Re: Public Comments on DNR's Draft Visibility SIP

Re: Comments on Draft BART Determination for Georgia Pacific Consumer Products LP

National Park Service Comments
Wisconsin Revised Draft Regional Haze State Implementation Plan
September 2, 2011

USDA Forest Service Technical Comments on the Regional Haze State Implementation Plan (RH SIP) for Wisconsin

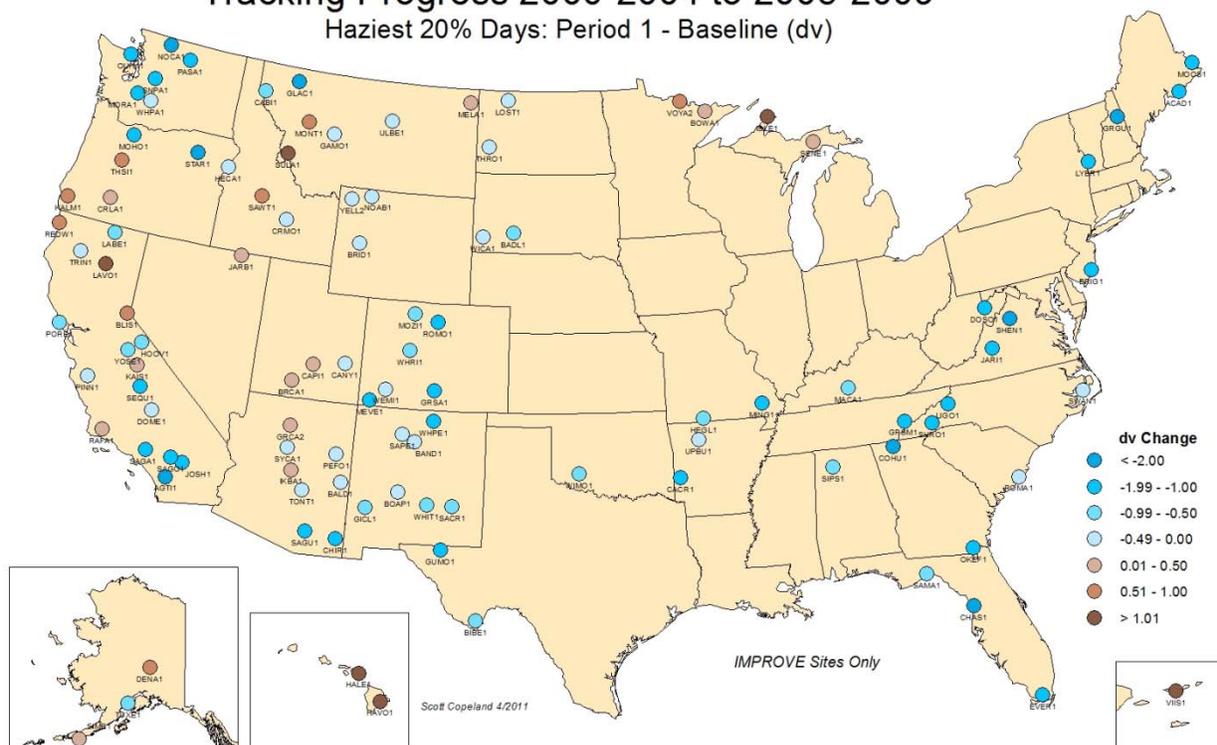
8. Analysis of recent visibility data shows that in the eastern US only the Northern Class I Areas have degraded since the baseline period (see figure below from upcoming IMPROVE Report). This means the amount of work to achieve the RPGs has increased. Please note this in the SIP.
